## Design Team Point of View

*Item 3, 11/15/23 CHB HARRIS*  
 EXH. A: EXCERPTS CHB STAFF REPORT (12/17/1980)

RE: Nomination of the Eastside Social Services Center (the former University Heights Junior High School) to CHB Landmark Status.

EXH.B: E/W PAVILION, EASTERN ENTRANCE

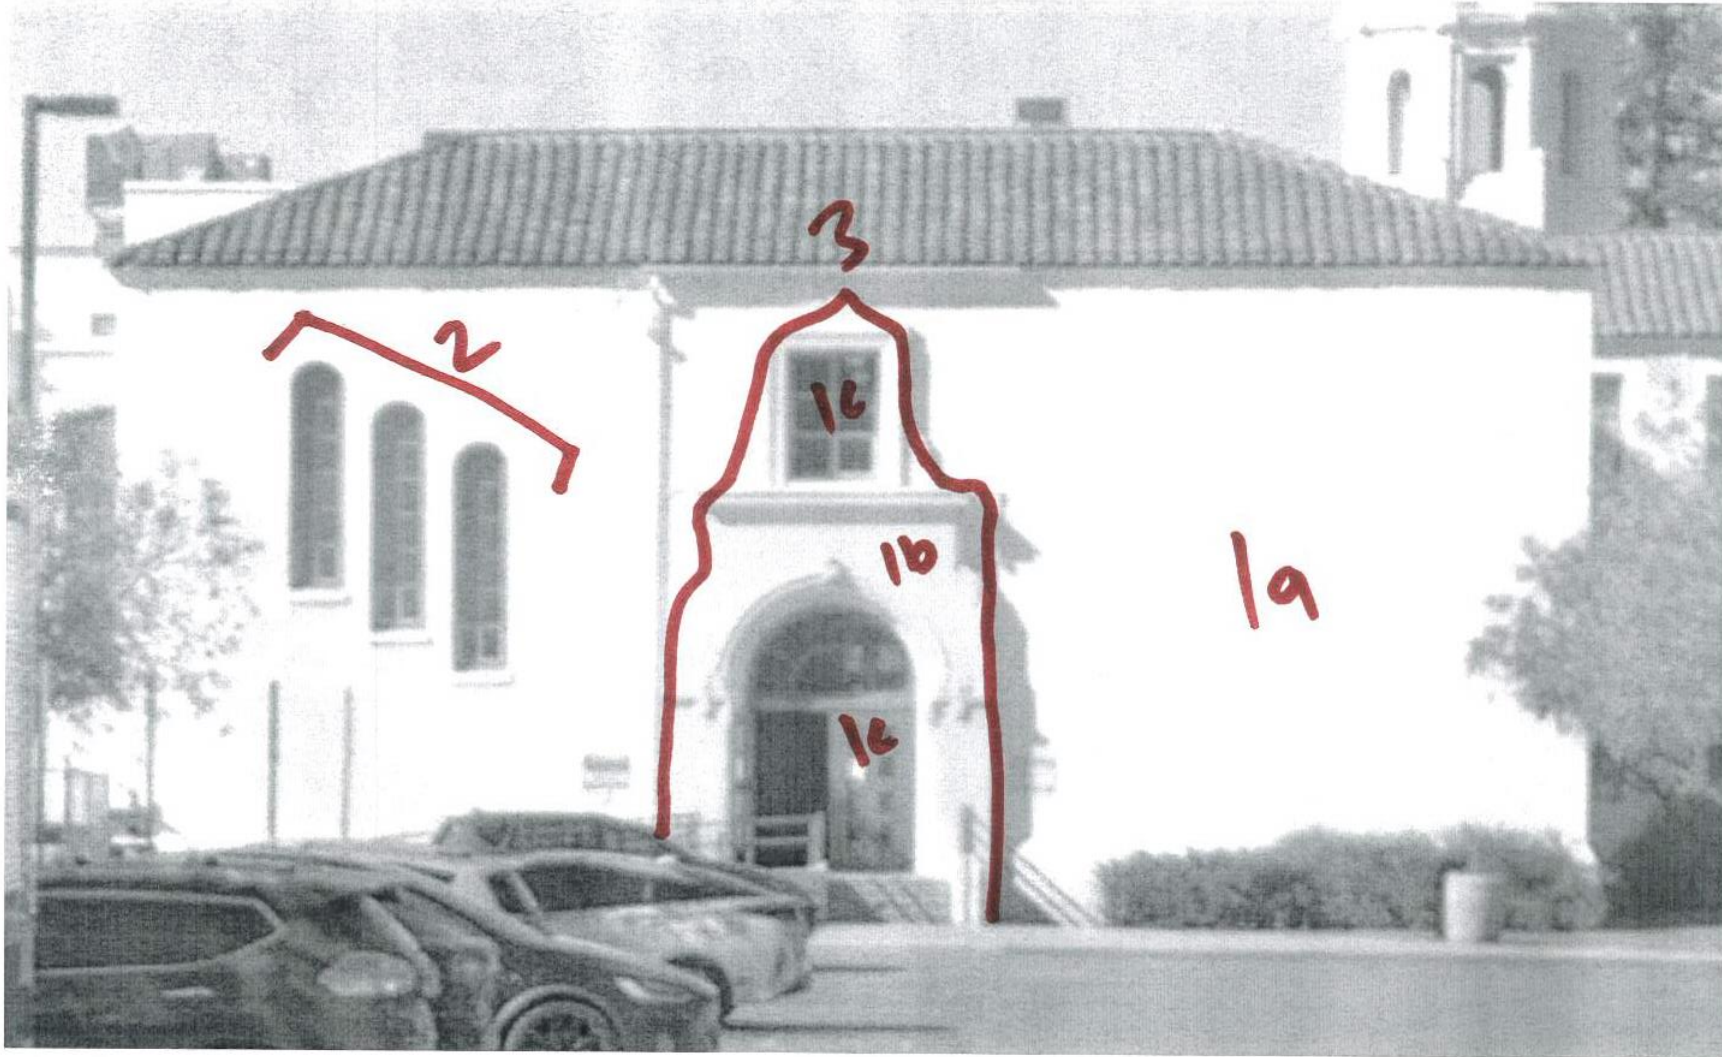
- (1) three main colors, including (a) white main body, (b) off-white accent punctuated entrance, (c) red trim for roof tile and window/door;
- (2) 3 stepped 12-light narrow arched windows;
- (3) punctuated/projected/modest detailed entrance.

1. We have mirrored the same use of off white for the body of the Library building

The scale of the Library is much smaller so we have used one color to unify the building and create visual calmness.

The single use of color also assists with ongoing ease of maintenance by reducing the need to store multiple color paints on site for touch ups etc.

EXH.B: E/W PAVILION, EASTERN ENTRANCE

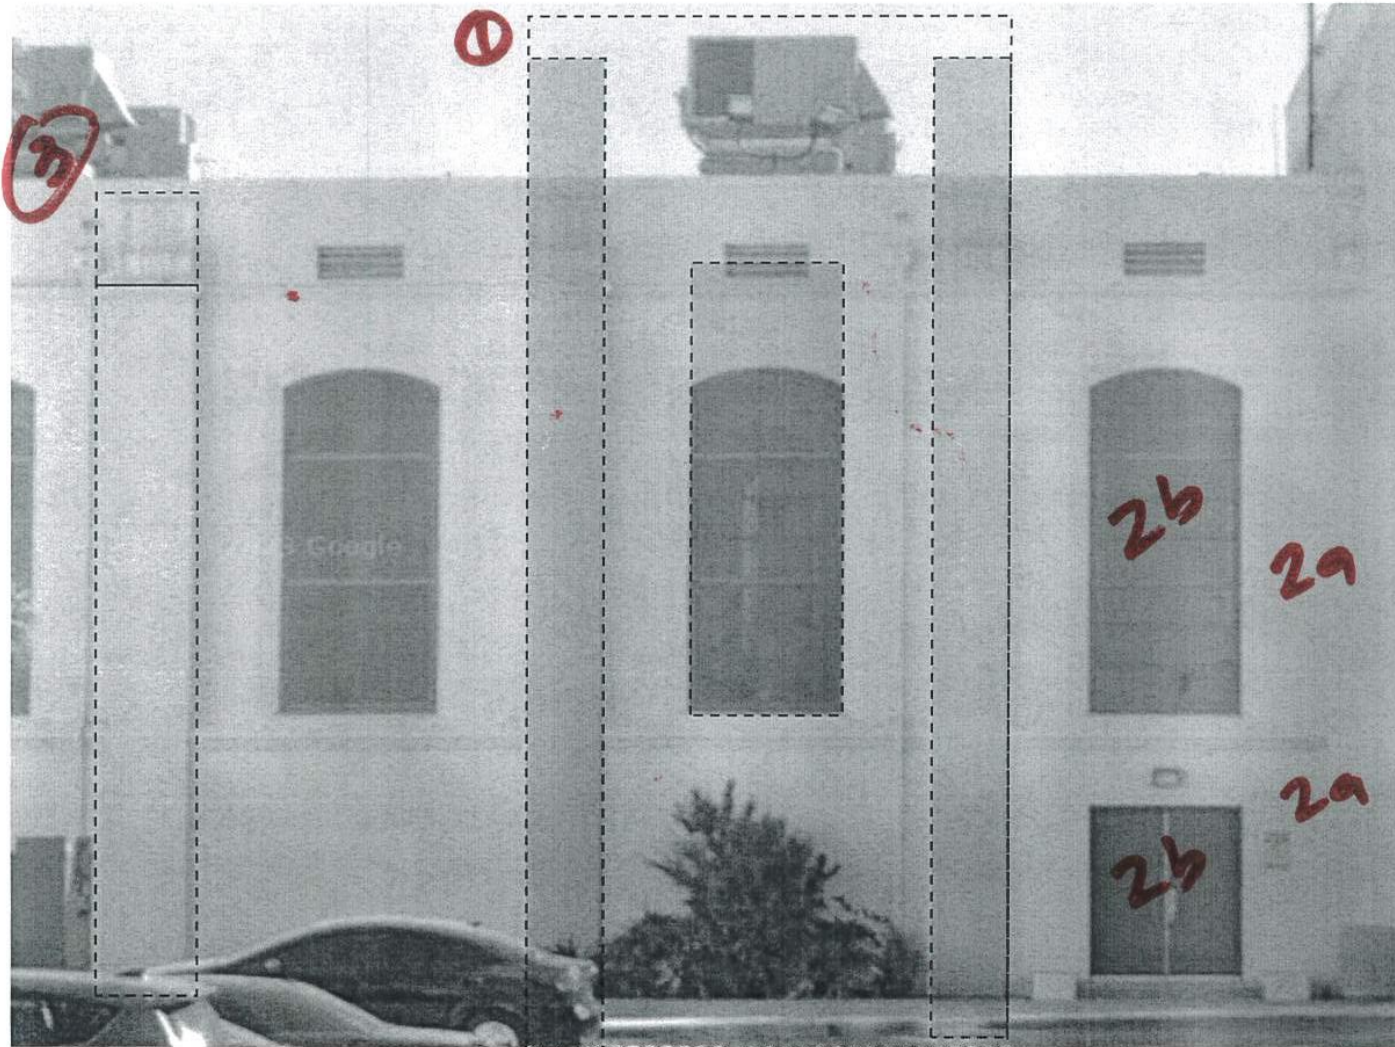
- (1) three main colors, including (a) white main body, (b) off-white accent punctuated entrance, (c) red trim for roof tile and window/door;
- (2) 3 stepped 12-light narrow arched windows;
- (3) punctuated/projected/modest detailed entrance.

2. These windows likely bring light into an interior stair.

The Library is completely glazed, but the rhythm of the structure can be seen as repetitive in a similar way.

3. The Library building has a clear entry portal frame identifying the entry to the building in a similar yet modern way.

EXH. C: N/W CROSS WING, WESTERN FAÇADE (SIMILAR TO EASTERN FAÇADE)

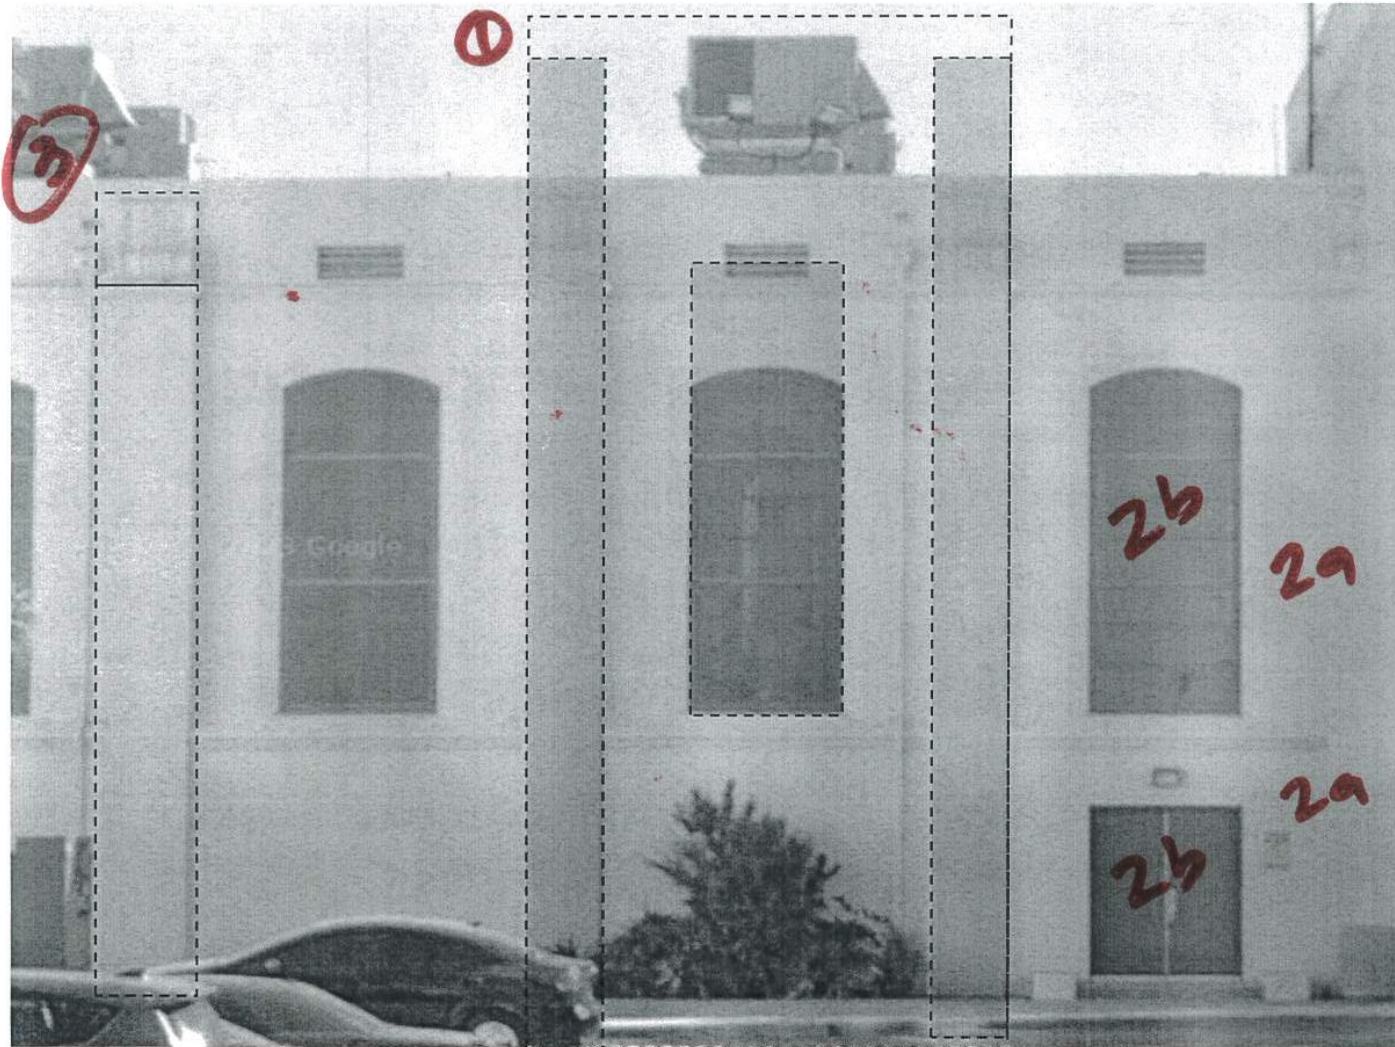
- (1) scale/proportions of the bays;
- (2) main colors (a) white main body and (b) red trim;
- (3) engaged pier topped with scroll console

1. The Library also presents a repetitive rhythm of standardized bays that are appropriately scaled to the height of the building to create a friendly interior environment for the users.
2. Discussed in Exhibit B
3. The top of the column expression is a decorative element used at the time of the building's construction to tell a story or create ornamentation on the building and is not used in modern design and construction.

EXH. C: N/W CROSS WING, WESTERN FAÇADE (SIMILAR TO EASTERN FAÇADE)

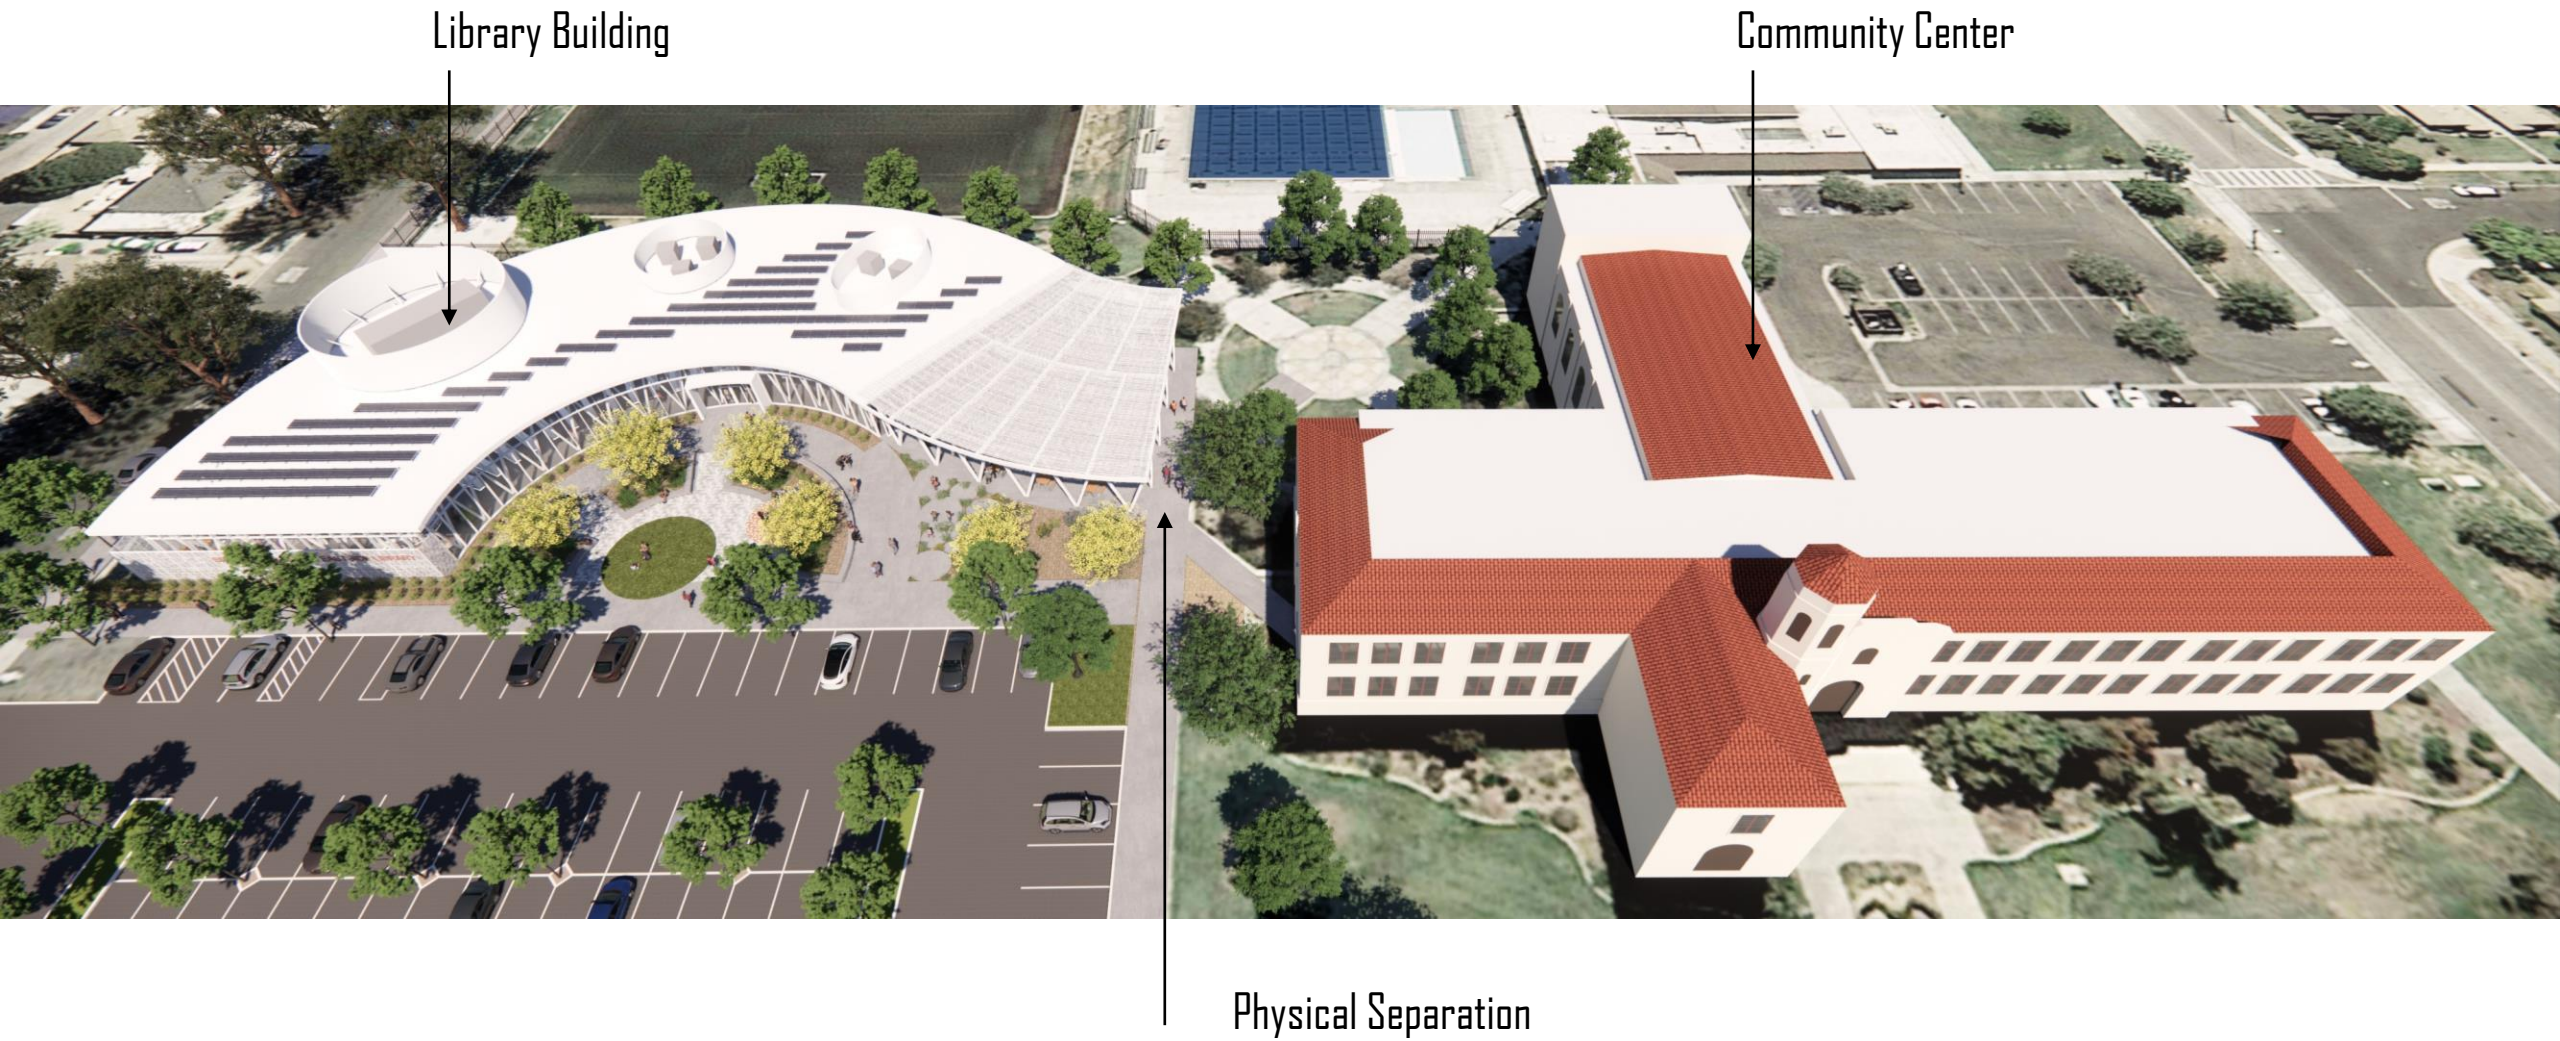
- (1) scale/proportions of the bays;
- (2) main colors (a) white main body and (b) red trim;
- (3) engaged pier topped with scroll console

3. In lieu, large graphic murals on the interior of the building in partnership with the community will express the unique cultural story of the neighborhood seen from the exterior. In addition, the exterior solar screen expresses a decorative pattern derived from the structure of the building. This patterning will become a character defining feature of the Library in a similar way over the years to come.

EXH. E: VOCATIONAL BUILDING, NORTHERN ENTRANCE

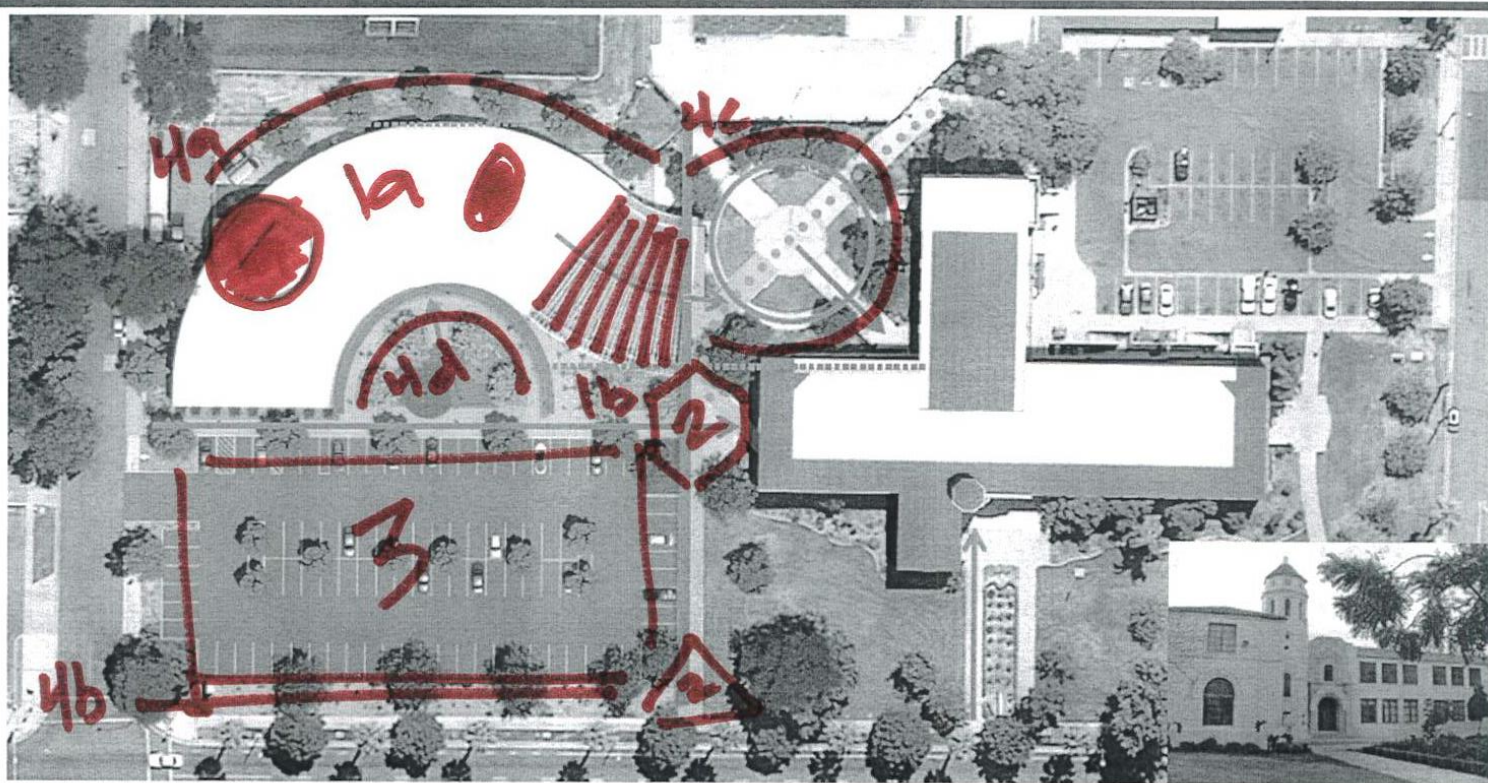
- (1) signage of shop building, should be salvaged and/or adaptively incorporated

- 1. Discussed in Exhibit B

EXH. F: DESIGN CONCEPT (PRESENTATION, P. 4)

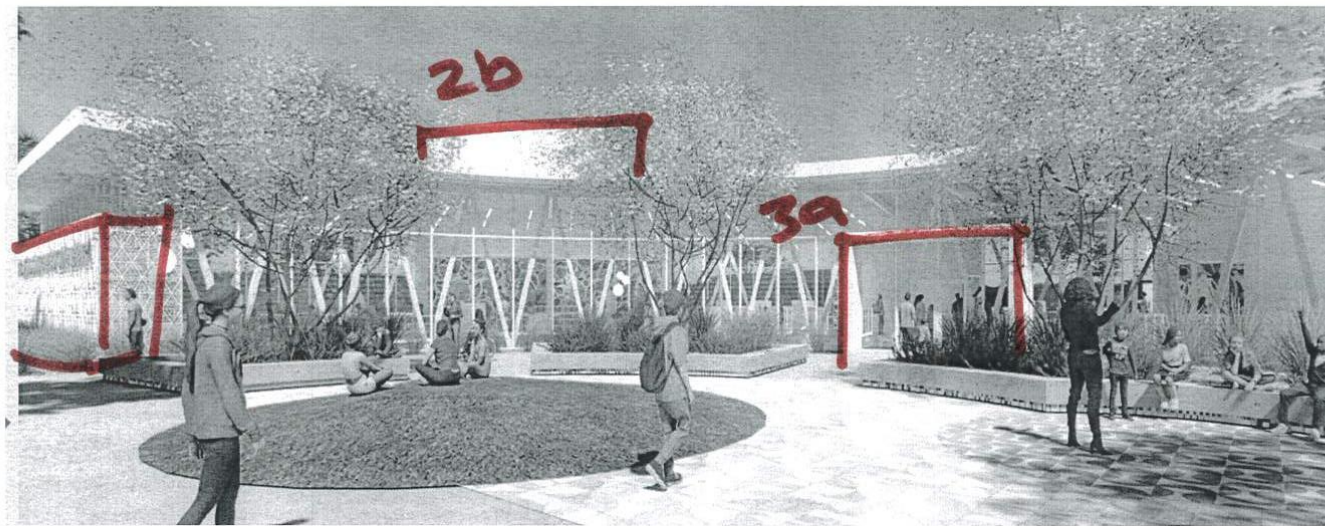
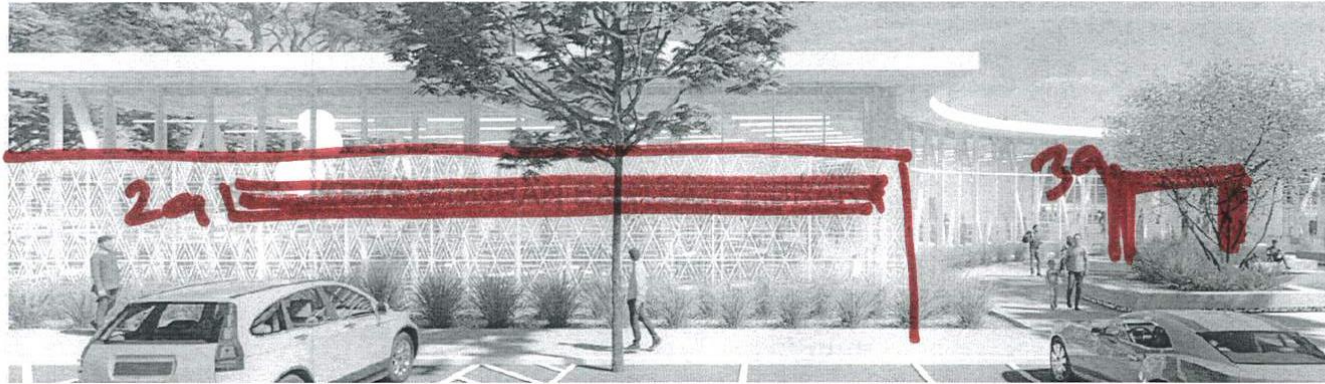
- (1) echo Landmark's 3-color scheme with red trim(e.g., trim/roof tile) for proposed project (a) roof projections, (b) louver canopy
- (2) pedestrian access from university needs much greater emphasis
- (3) great to see grass/permeable paver system in the front parking lot and elsewhere (see also Exh. K)
- (4) relocation/incorporation of mature trees that may be removed to be incorporated elsewhere on the site, such as (a) south boundary of project site adjacent of soccer fields, (b) north boundary of project site along university, (c) outdoor plaza, or (d) front entrance

1. Discussed in Exhibit B. The Library is not part of a "campus" where common standards of color and material use are required. The transfer of color elements to the roof of the Library would lead to confusion about the identity of the Library.
2. The pedestrian pathway from University is not part of the scope of work boundary for the Library.
3. The parking lot is being reconfigured, restriped and landscaped. This also includes new parking lot lighting for added safety and public enhancement.
4. This would be an owner's consideration since it is outside the scope of work for the Library building.
